HISTORIC AND DESIGN REVIEW COMMISSION

HDRC CASE NO: 2022-315
COMMON NAME: 1014 N CHERRY
ADDRESS: 1012 N CHERRY
LEGAL DESCRIPTION: NCB 512 BLK 25 LOT 6 HS
ZONING: RM-6, H
CITY COUNCIL DIST.: 2
DISTRICT: Dignowity Hill Historic District
APPLICANT: Ricardo Turrubiates/Mint Development LLC
OWNER: DELAFIELD INVESTMENTS LLC
TYPE OF WORK: Construction of six, 2-story residential structures
APPLICATION RECEIVED: May 27, 2022
60-DAY REVIEW: Not applicable due to City Council Emergency Orders
CASE MANAGER: Edward Hall

The applicant is requesting a Certificate of Appropriateness for approval to construct six, 2-story residential structures on the vacant lots at 1012 and 1014 N Cherry, located within the Dignowity Hill Historic District.

ADDRESS	SETBACK FROM CURB
1.	1026 N Cherry St	26.50'
2.	1024 N Cherry St	37.83'
3.	1018 N Cherry St	38.25'
4.	1010 N Cherry St	17.00'

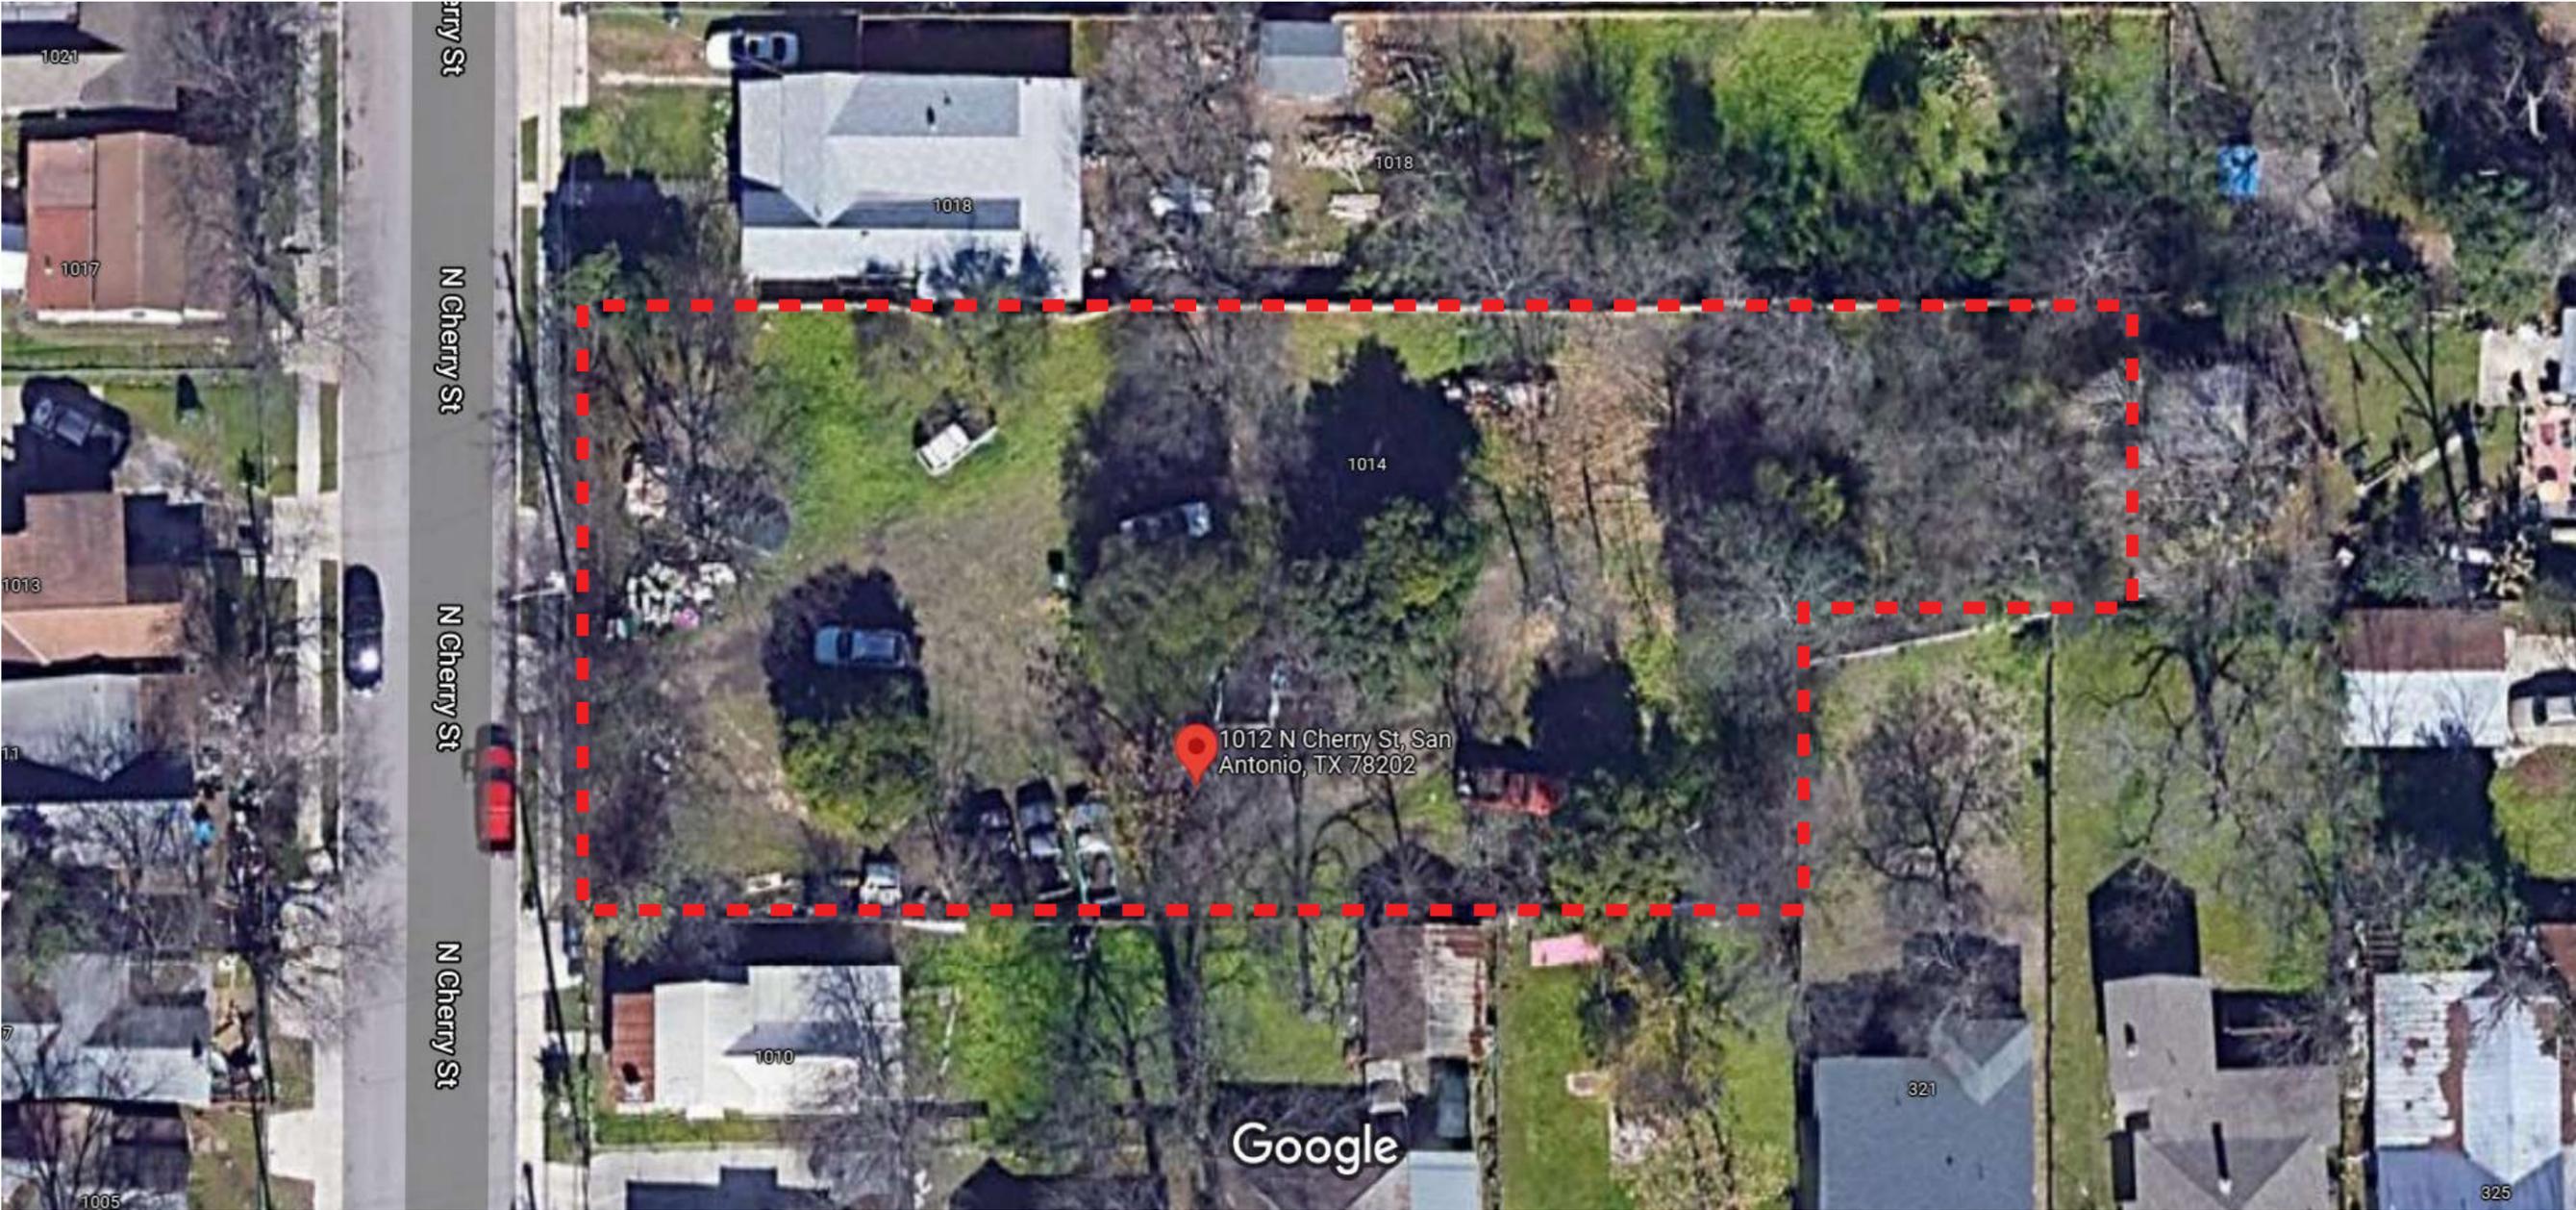
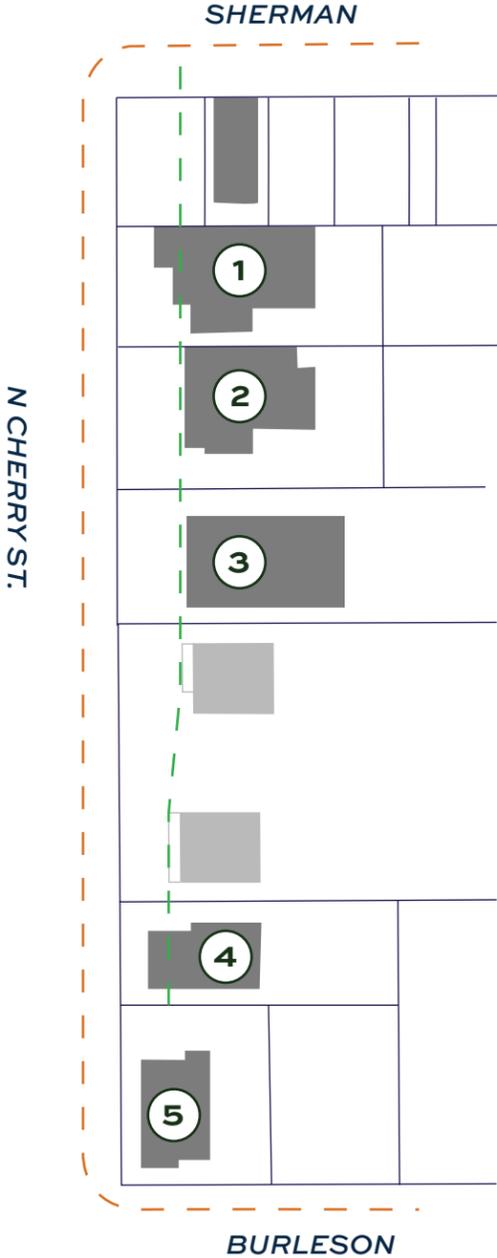
- That the site plan be developed to better document conformance with the Guidelines. *This stipulation has been met.*
 - That the applicant increase the proposed front setbacks. Per the revised site plan, there appears to be room to increase the front setbacks. (The Commission included this stipulation with the note that the applicant should increase the setbacks at the street.) *This stipulation has been met.*

1 TYPICAL WALL SECTION - STUCCO
SCALE: 3/4"=1'-0"

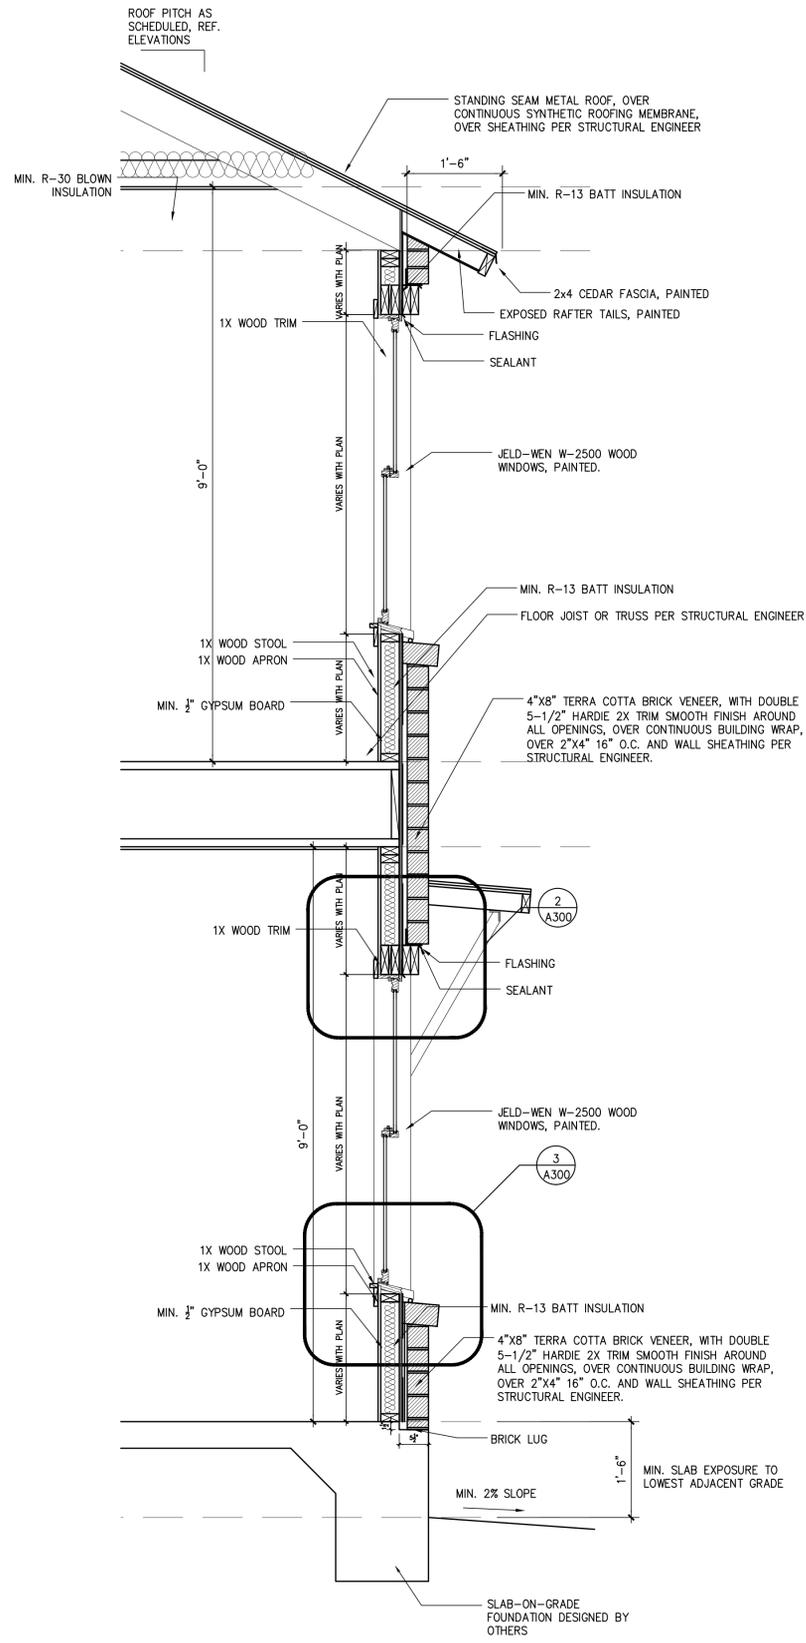
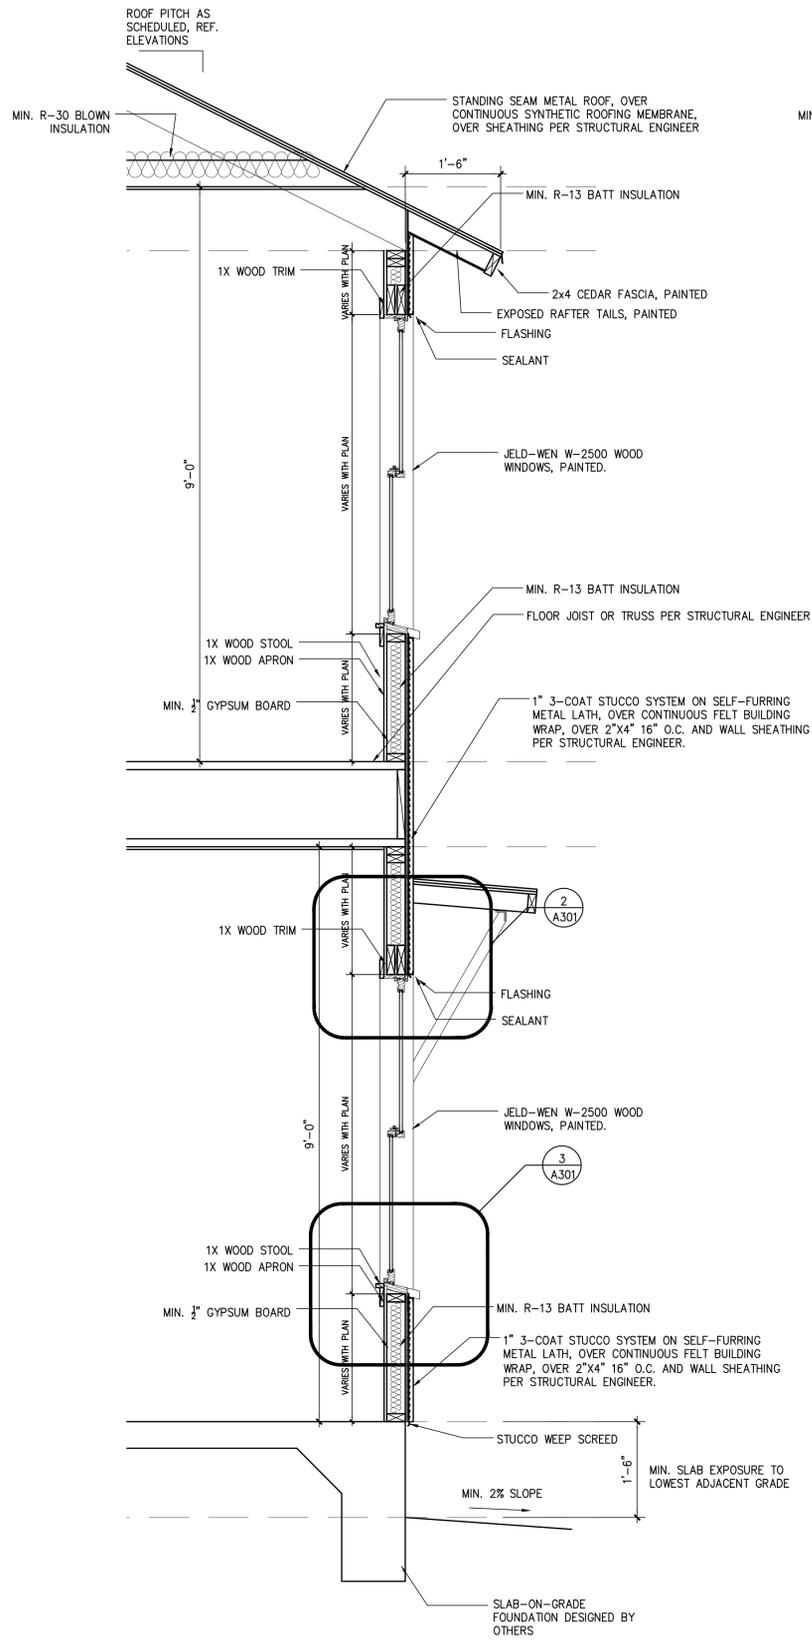
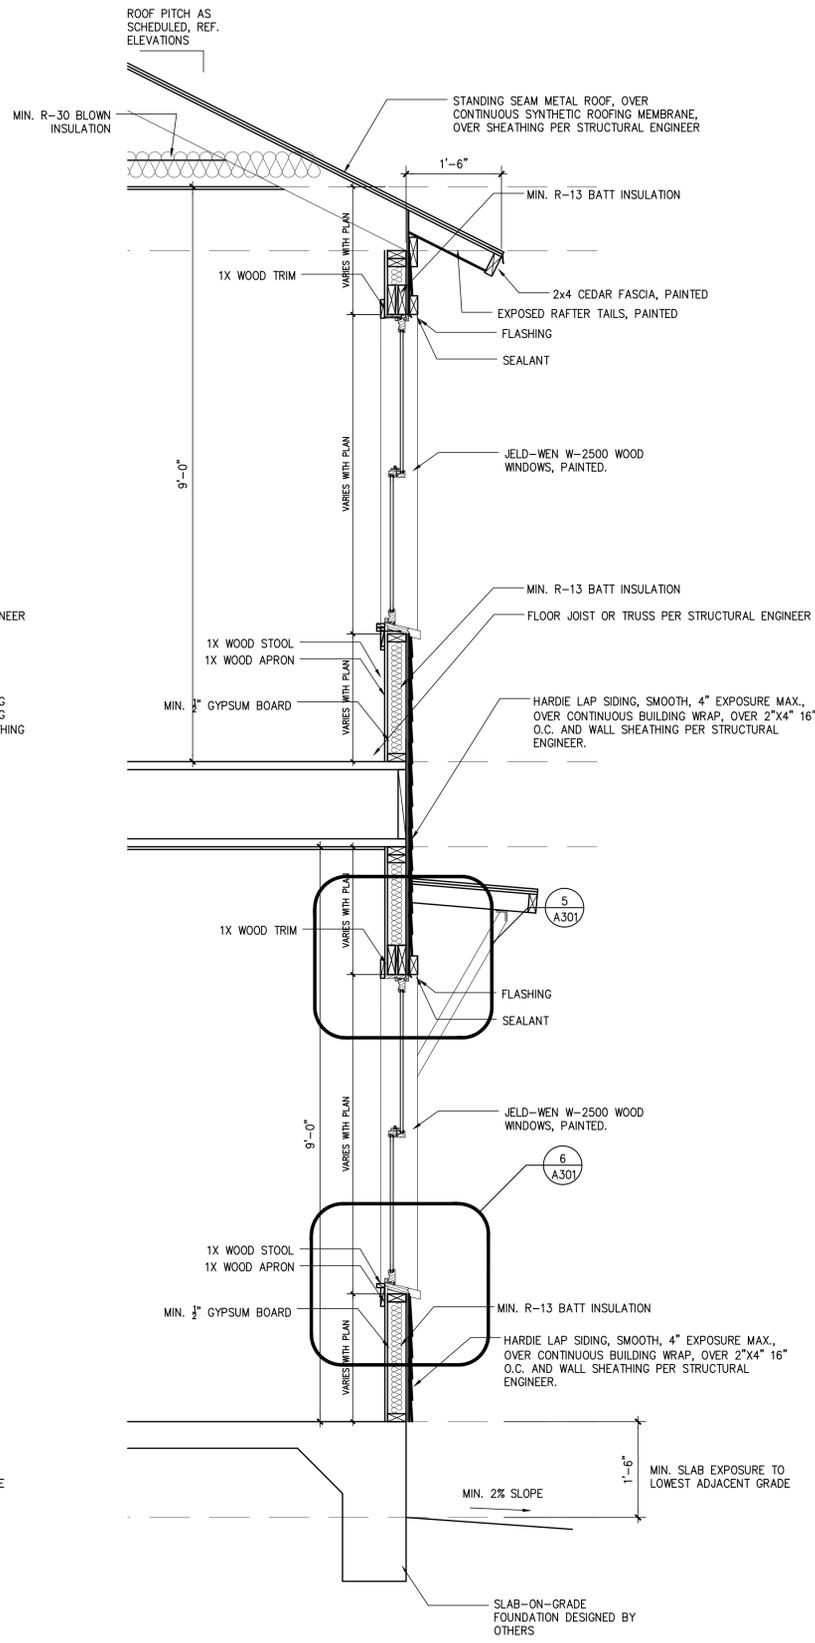
LG: Questions about window recess at stucco? No sections have been submitted to note this. Windows appear to be extrude from walls at stucco.
